PMIC

MODEL	OTQ N3
Sheet Name	4_PM_IC/BATTERY
File Name	OT_N3_LS_Main_Rev00_24026_1430.sch
Revision	0.0
Release Date	2024-02-26
Drawn by

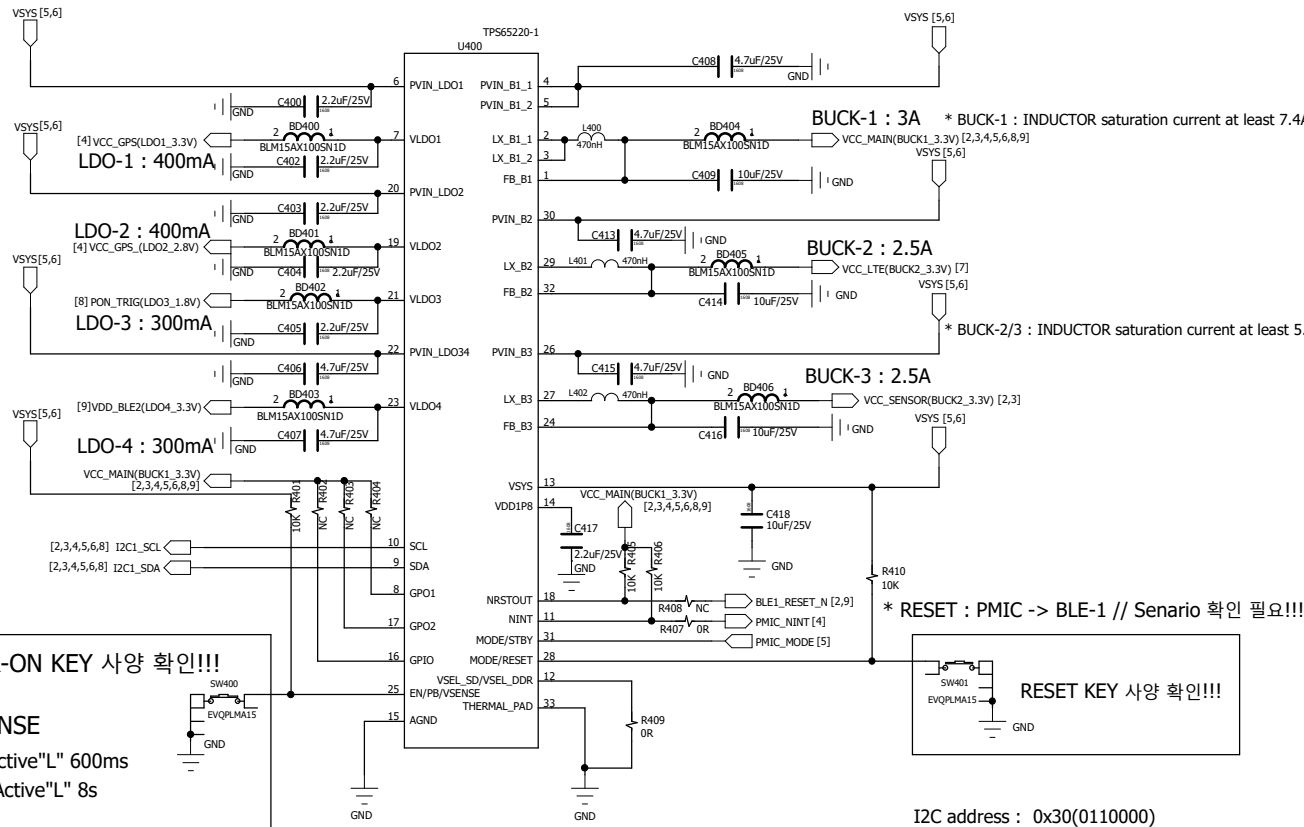
*** DUT POWER-ON KEY 사양 확인!!!**
 * EN/PB/VSENSE
 PMIC-ON : Active"L" 600ms
 PMIC-OFF : Active"L" 8s

* RESET : PMIC -> BLE-1 // Senario 확인 필요!!!

BATT_Li-Po

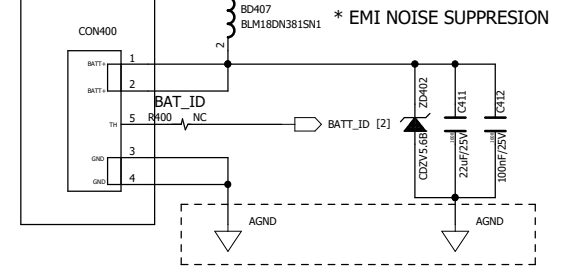
사양 변경 : 업체 Recommend!!!

BAT 단자 5P : 1.25Pitch Right-angle SMD
 BAT_ID : BAT 사양 CHECK!!!

* Modify_0223

FUEL_GAUGE

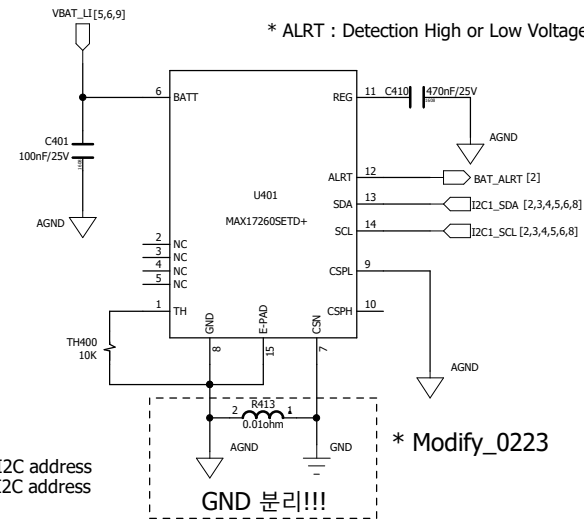
* Modify_0223

GND 분리!!!
